## VALLIMAR SUBDIVISION ADDITION

The plat illustrates the proposed 6 lot,  $12.8 \pm$  acre subdivision which is located on the South side of Blackwell Nursery Road,  $715' \pm$  West of Snow Road. The subdivision is served by city water and individual septic systems.

The purpose of this application is to subdivide two existing metes and bounds parcels into six lots of record.

## DETAIL SITE PLAN

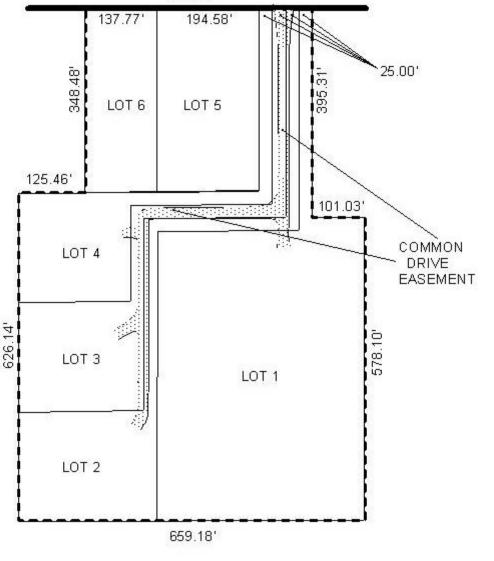
While the Commission has approved flag lot subdivisions in the past typically these subdivisions were in character with the surrounding area, this subdivision proposes <u>six</u> lots, four of which are flag-shaped. The commission has recently struggled with developing a policy regarding flag-shaped lots; however, the proposed plat has <u>four</u> flag-shaped lots. As illustrated on the Vicinity Maps there are no flag-shaped lots in the area.

Additionally, Section V.D.3 states that the depth of the lot not exceed 3.5 times the width. While the Commission sometimes waives this requirement the lots are typically fronting waterways and are approved with no more than two "flag" shaped lots. In this situation the "flags" are substantially larger than the minimum area requirements of the Subdivision Regulations and has the potential for resubdivision, especially Lot 1 which is approximately larger than five acres.

The application should be resubmitted showing a reconfiguration of the lots to be more agreeable to resubdivision in the future.

Based upon the preceding, this application is recommended for holdover until the April 3<sup>rd</sup> Planning Commission meeting to allow the applicant to address the concerns mentioned in this report. This information would be required by March 24<sup>th</sup>.
